This gallery shows some pictures of bad solderings - they should prevent you from making the same errors (feel free to add even more pictures here!)

From:  
<http://midibox.org/dokuwiki/> - MIDibox

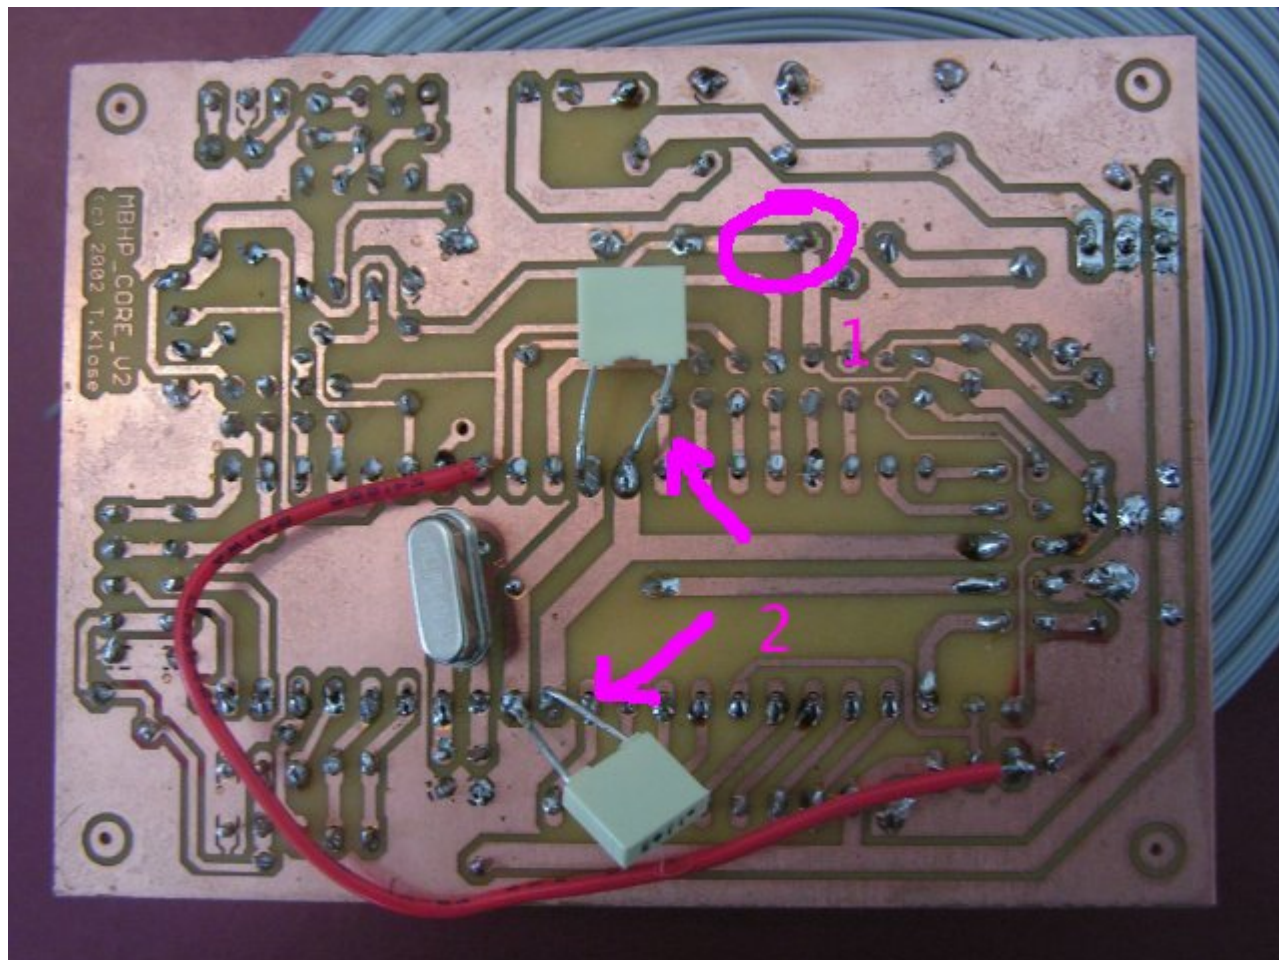
1: The core module has some badly soldered connections(loose), which could lead to failures. There are also missing solderings (e.g. 33pF cap below crystal). It makes sense to solder each pad again, the [Soldering](#) guide in the Wiki gives some useful tips

2: The legs of the caps should be cut, otherwise they can cause a short circuit which can damage the PIC!

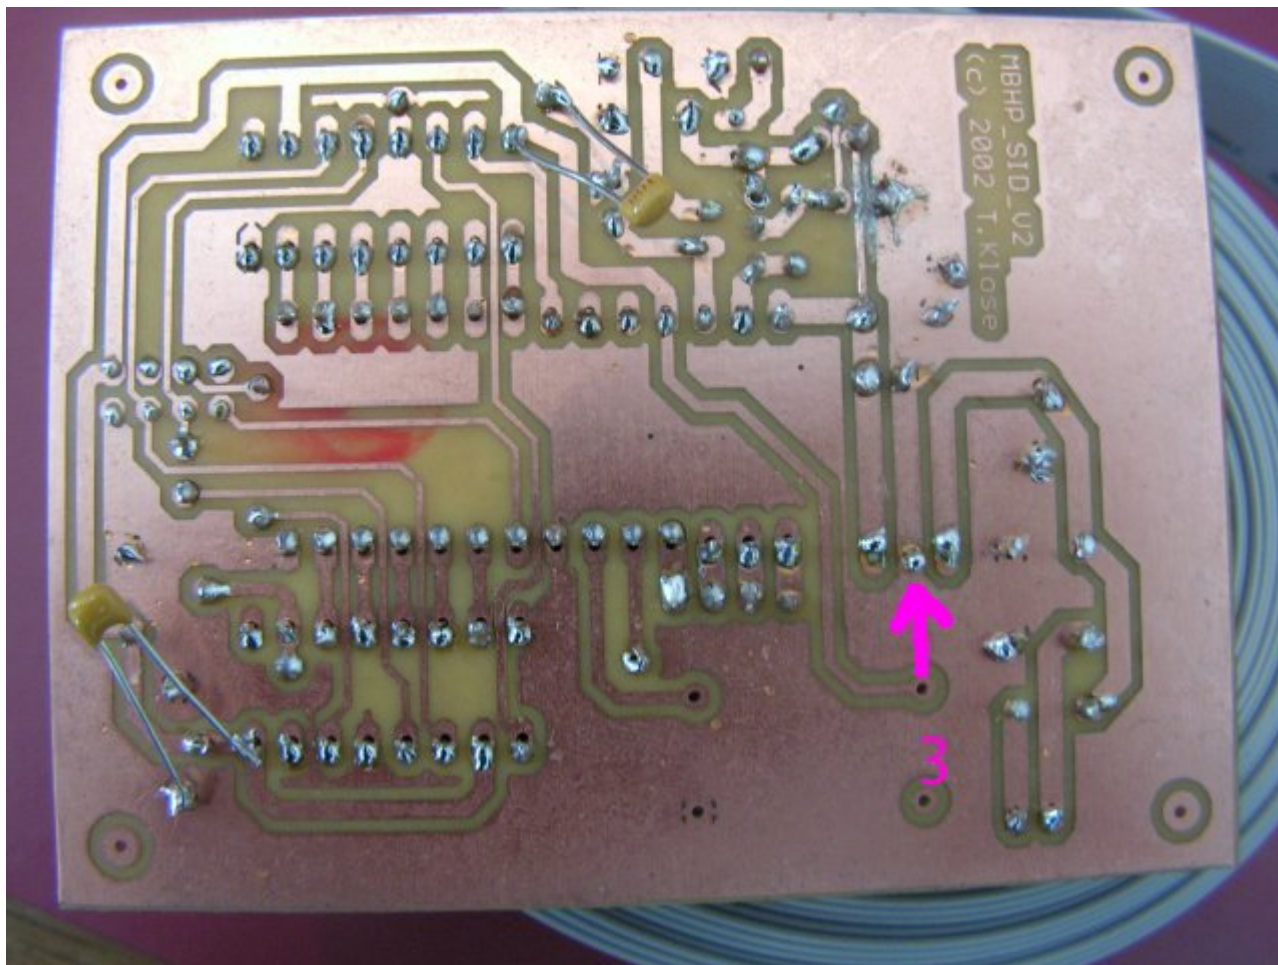
3: This seems to be a bad ground connection directly at the 78xx - it can lead to the wrong voltage. Here the same: just solder the pads again, it will help  
And same as above: the long cap legs need to be cut, the danger of shorting out is too high!
